Murphy Creek East

Framework Development Plan (Official Project Name)

Murphy Creek East Framework Development Plan

Issue Date: 8/20/01  
 Revision Date:  
 Sheet Title: Public Improvem Phasing I  
 Sheet Number: 8 of 8

Sheet Title: Cover Sheet

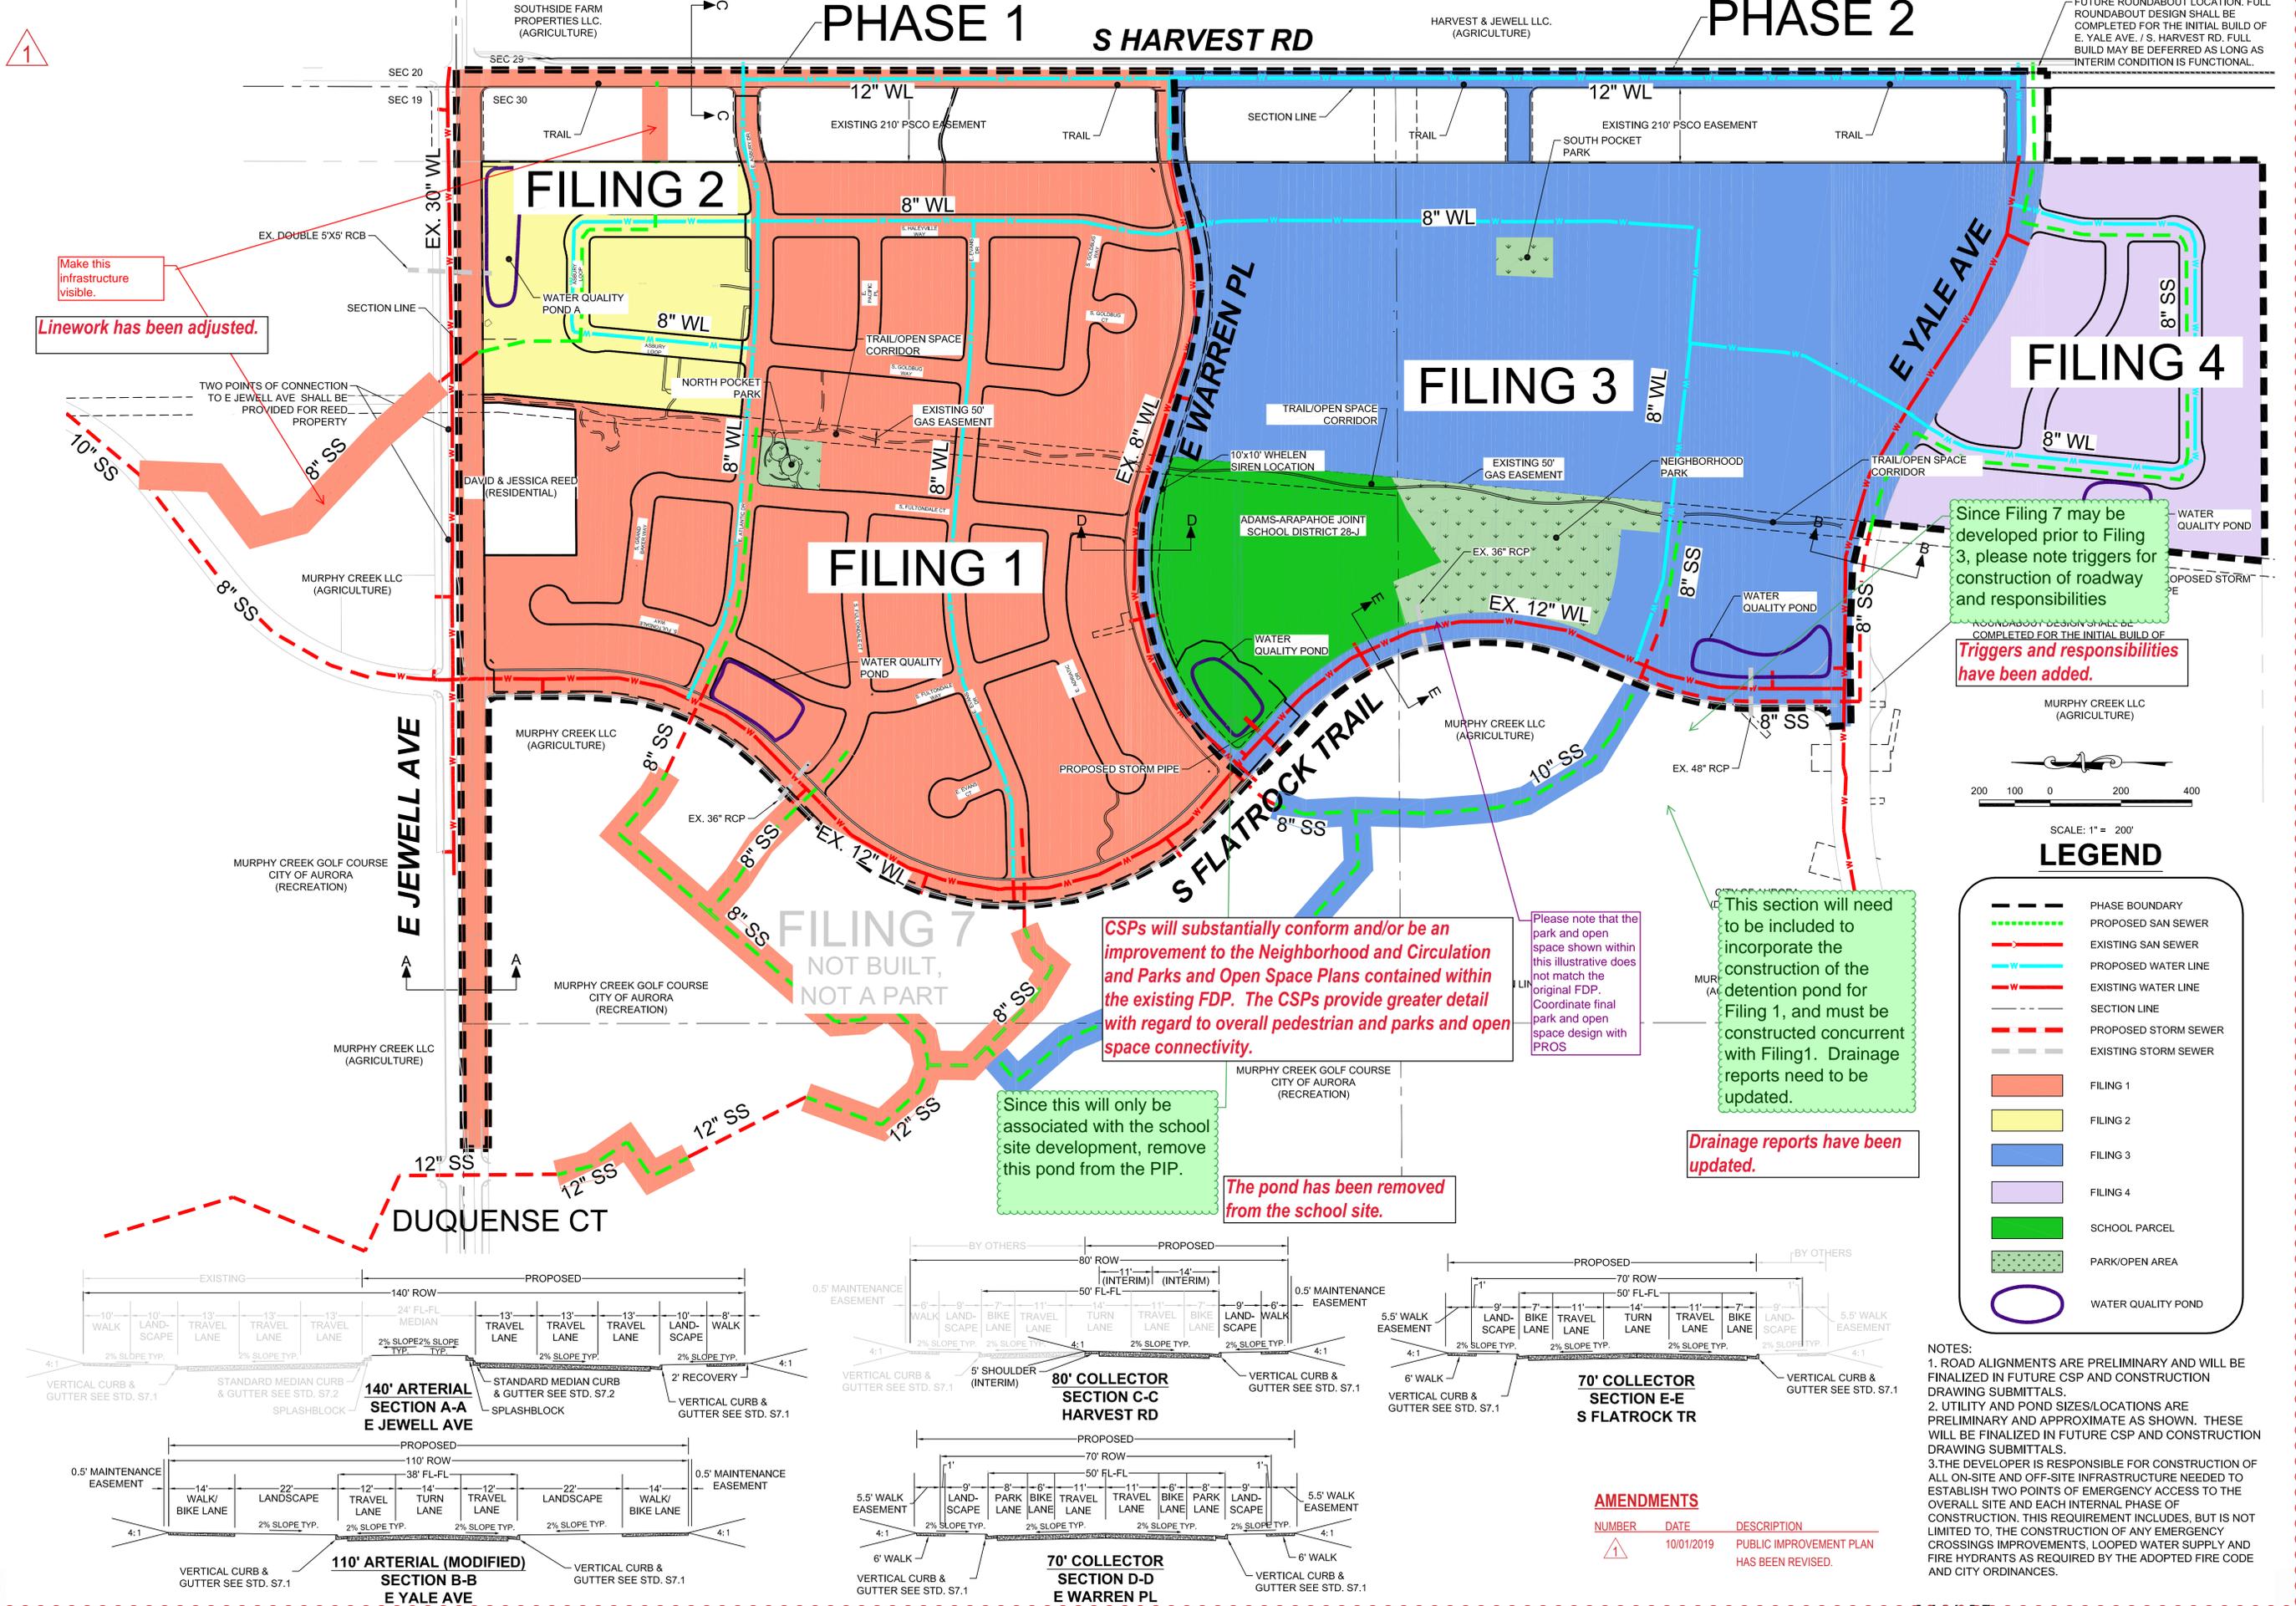
The amendment should include an update to the lot sizes and number of small lots with a statement of conformance with the Unified Development Ordinance.

Doesn't the legal description need to be updated? As well as the other associated tables in the Master Plan that account for the change in property area?

The FDP amendment will not be approved by public works until the master drainage update is approved.

The CSPs are required to be compliant with the lot standards contained within the UDO and therefore a statement of conformance is not necessary. The number of small lots is regulated by the UDO. Per request by staff to aid with clarification, Sheet A-3 has been added to the Master Plan amendment and the following note has been added: complies with current code.

A change in the legal description within the FDP is not being requested by the Applicant. The FDP applies to all of the property in the CSP applications. Per staff recommendation, a mylar change may be warranted at a later date.

Comment noted, thank you.

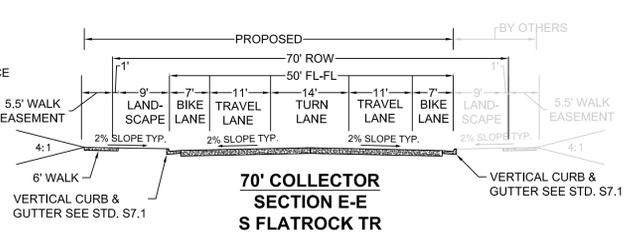
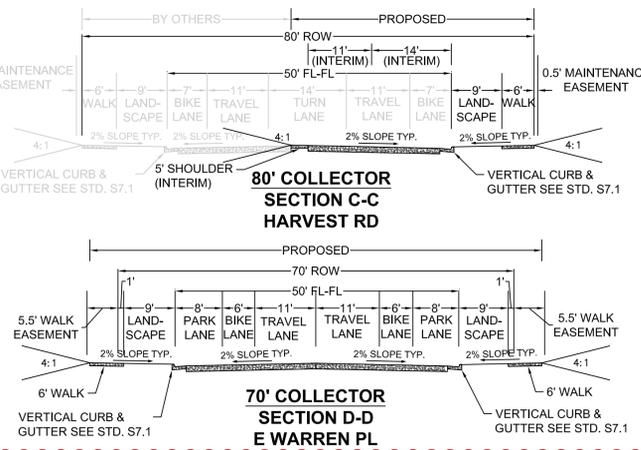
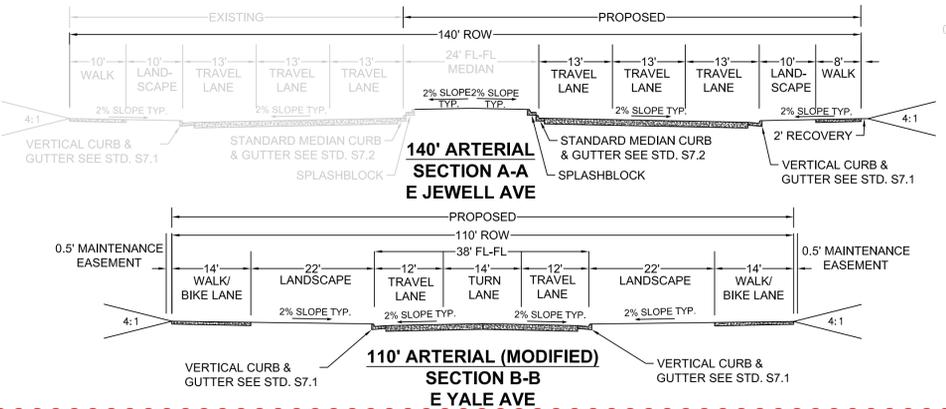
Make this infrastructure visible.  
 Linework has been adjusted.

Since Filing 7 may be developed prior to Filing 3, please note triggers for construction of roadway and responsibilities  
 Triggers and responsibilities have been added.

Since this will only be associated with the school site development, remove this pond from the PIP.

This section will need to be included to incorporate the construction of the detention pond for Filing 1, and must be constructed concurrent with Filing 1. Drainage reports need to be updated.

Please note that the park and open space shown within this illustrative does not match the original FDP. Coordinate final park and open space design with PROS

CSPs will substantially conform and/or be an improvement to the Neighborhood and Circulation and Parks and Open Space Plans contained within the existing FDP. The CSPs provide greater detail with regard to overall pedestrian and parks and open space connectivity.

The pond has been removed from the school site.

Drainage reports have been updated.
